SERVICE MANUAL BULLETIN

SMB-142

ISSUE DATE: Apr 08 2015

1. Caliper Carrier

Fig. 1: Caliper Carrier Retaining Bolt

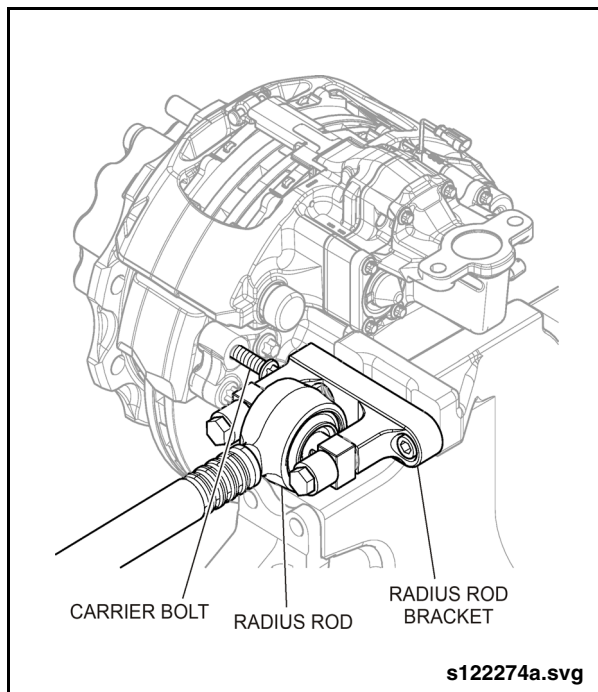
When servicing the ZF AVN-132 center axle caliper carrier, the M16 Hex head bolt located at the center in the caliper carrier cannot be fully removed as it will come into contact with the upper radius rod retaining bracket. See “Fig. 1: Caliper Carrier Retaining Bolt” on page 2.

The axle OEM has approved the reuse of this one bolt if, upon inspection, it is determined not to exhibit signs of stress, corrosion, damage or deformity.

Upon inspection, if it is determined that the bolt cannot be reused, it will be necessary to remove the radius rod bracket to facilitate replacement of the damaged bolt.
